# Port Phillip 'Pop-up' Bike Lane Infrastructure

## Independent Transport Review

Prepared for  
Port Phillip Residents

G32421R-01C

Figure 3: Conventional Arrangement with Left Turn Lane on Left Side of Bicycle Lane on Approach to Signals

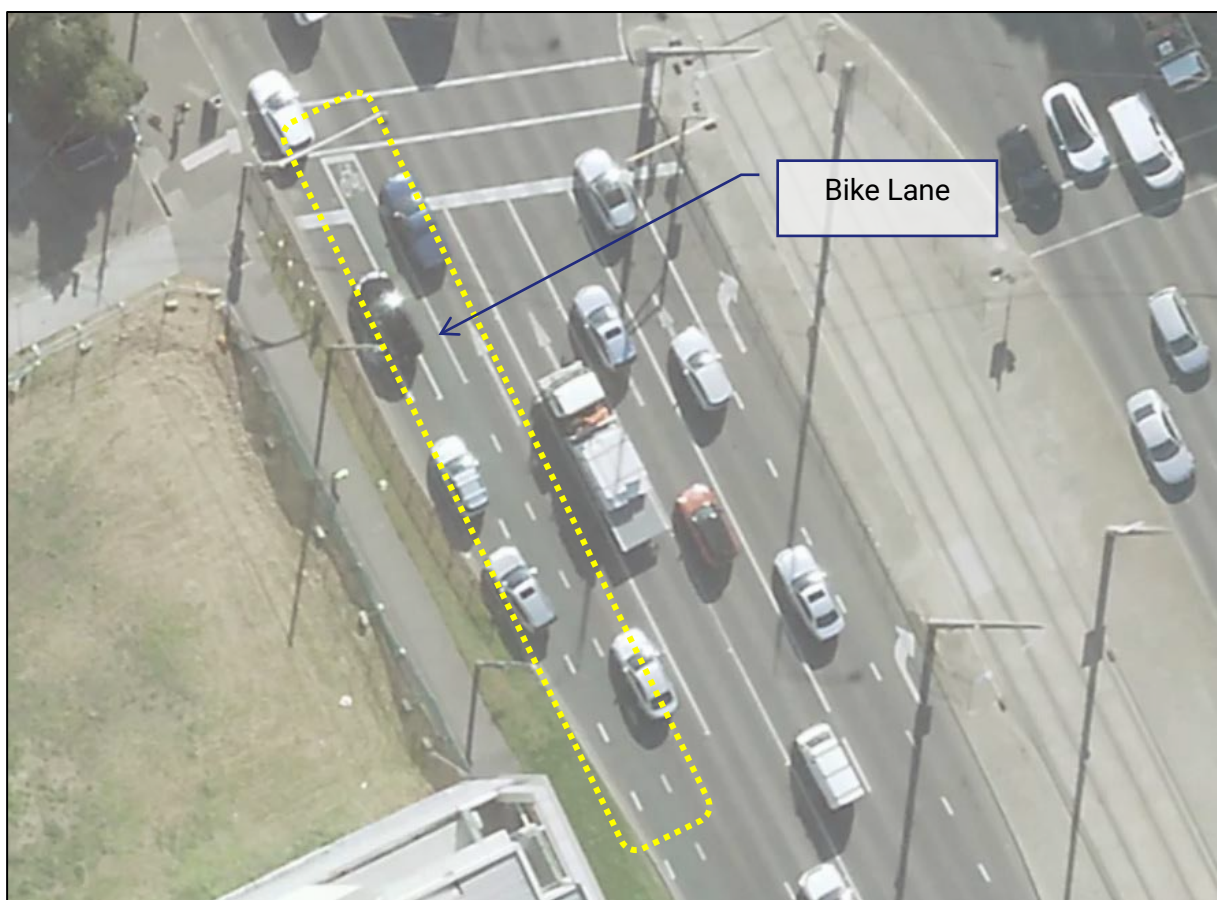
Similar to the treatment along Marine Parade, the presence of a bicycle lane on the left side of left turning traffic will create conflicts on the approaches to the intersections at Kings Way and Moray Street at either end of the treatment.

This could be addressed by swapping the positioning of the left turn lane and bicycle lane on approach to King Street and by ceasing the bicycle lane short of the Moray Street intersection.

A typical example of where the left turn lane is provided on the left side of the bicycle lane on approach to a signalised intersection is presented in the example at Figure 3 on the Brighton Road southern approach to Carlisle Street.

In this regard, if cycling treatments on this section of road are to become permanent, a more conventional arrangement whereby the on-street parking is on the kerb side of the bicycle lanes would provide a safer outcome by improving visibility at vehicle crossovers and also assist with left turning traffic at the major intersections at each end. Additionally, we are of the view it is a safer outcome for pedestrians accessing vehicles within the parking lane.

*Figure 9: Pop-up Infrastructure at Lyons St/Bridge St and Lyons St/Esplanade West Intersections*

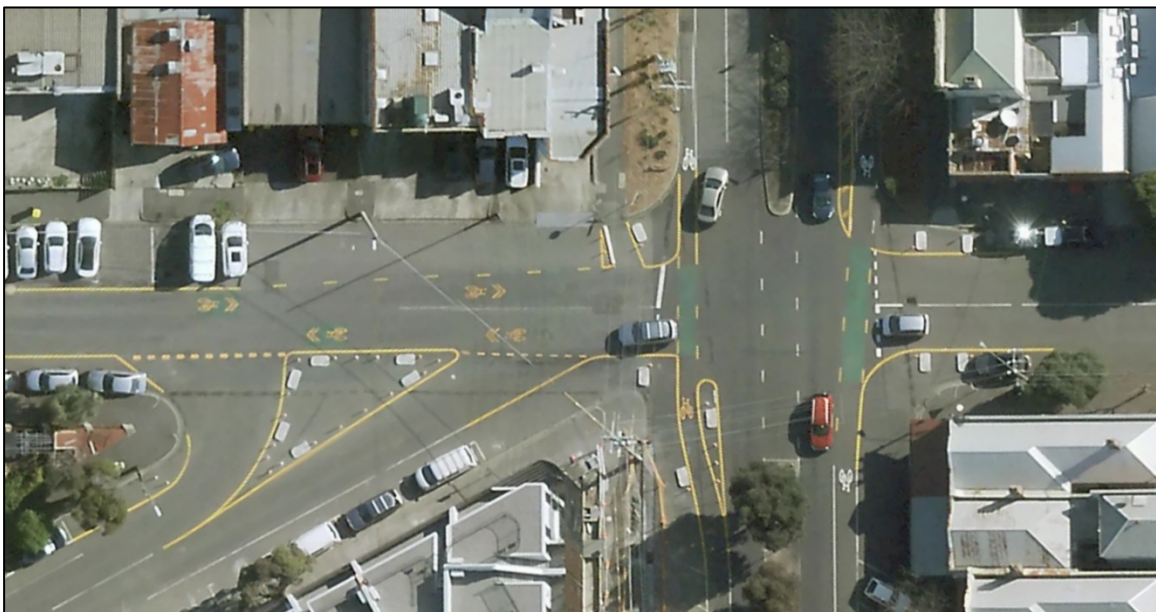
The change to the cross-section of Lyons Street to the west of Esplanade West has resulted in a 3.0m parking lane on the eastern side of the road and only 5.6m for two-way traffic including cyclists between edge lines.

This is likely to result in vehicles parked further from the kerb and an increased risk of collisions between passing vehicles due to the narrower carriageway. However, the presence of the sharrows might mitigate this to some extent by drawing attention that cyclists use this route.

The introduction of the wide splitter island (by concrete blocks and bollards) in Esplanade West results in motorists turning right to exit Esplanade West into Lyons Street turning at closer to 90 degrees. This is considered to provide a safety improvement for both motorists and cyclists as they will not have to turn their head as far to the left to see other vehicles approaching from the southern leg of Lyons Street. It also slows vehicles approaching from Esplanade West and prevents them from cutting the corner.

The reduction in width of the Lyons Street approaches to Bridge Street results in the need for vehicles to turn in and out of Lyons Street at an angle closer to 90 degrees, resulting in slower turning speeds. This is generally considered to provide a safer outcome for pedestrians as they reduce crossing distance in addition to the slower speed of vehicles.

Reducing the width of the Lyons Street approaches also forces cyclists to merge with other traffic when approaching the intersection rather than remaining to the left of motorists within a wide traffic lane that can accommodate both vehicles. This is not a positive outcome.

The pop-up treatment has resulted in the introduction of a kink in the westbound bicycle lane on Bridge Street on approach to the Lyons Street intersection that did not exist previously. The presence of this kink is not desirable as it may lead to cyclists losing control when approaching the intersection if not paying attention and may result in a collision with the concrete blocks and bollards.

The presence of the concrete blocks and bollards also results in greater separation of cyclists from left turning vehicles from Bridge Street and may result in cyclists not being aware of the need to give way to left turning vehicles as required under the road rules.

Overall, it is considered the concrete blocks separating the westbound bicycle lane and traffic lane on Bridge Street should be removed such that the kink in the bicycle lane can be avoided.

The Lyons Street cross-section to the west of Esplanade West should also be amended to include less width for the parallel parking lane on the eastern side of the street and more space for traffic movement including cyclists.

The wide splitter island in Esplanade West is considered to provide some safety benefit and is therefore recommended to be retained, albeit it should be made permanent through appropriate kerbing and landscaping to replace the concrete blocks and bollards.

It is considered the concrete blocks and bollards that narrow the width of the Lyons Street approaches should not be retained due to the greater potential for cyclists to be delayed behind through and right turning motorists, and associated risks as outlined above.
